Consumer Product Service
Manager of Technical Support
TECH TIP

MODEL: 410 Cassette Recorder

DATE: February 9, 1983

410 Cassette Recorders that register #143 error codes.

Figure 1. Output Signal
of the Preamplifier
Before Head Alignment

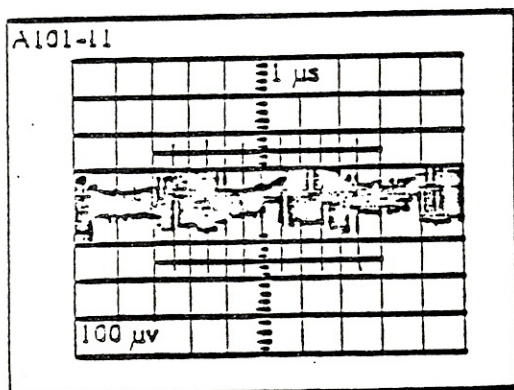
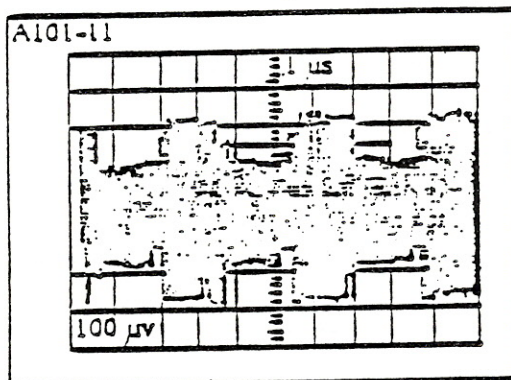
3. Clean the head and tape drive rollers. Check for stretched/worn belts.
4. Place the Test Tape in the unit.
5. a. Put scope probe on A101, Pin 11 (refer to Head Alignment procedure of Section IV of the Field Service Manual).
b. Type: POKE 54018,52 (turns motor on without error or actual load)
Press: RETURN (on computer)
This allows the tape to run continuously when PLAY is pressed on the recorder.
Press: PLAY (on recorder)
c. Adjust head-adjust screw clockwise or counter-clockwise and look for a signal of 300MV or greater (The manual's reference to a 50MV signal is incorrect and will be corrected in the next revision of the manual.) Refer to Figures 1 and 2 on the following page for examples of waveform patterns before and after head alignment. (If signal stops, rewind tape and press PLAY again. Repeat procedure as necessary until alignment is complete.)

Figure 2. Output Signal
of the Preamplifier
After Head Alignment.
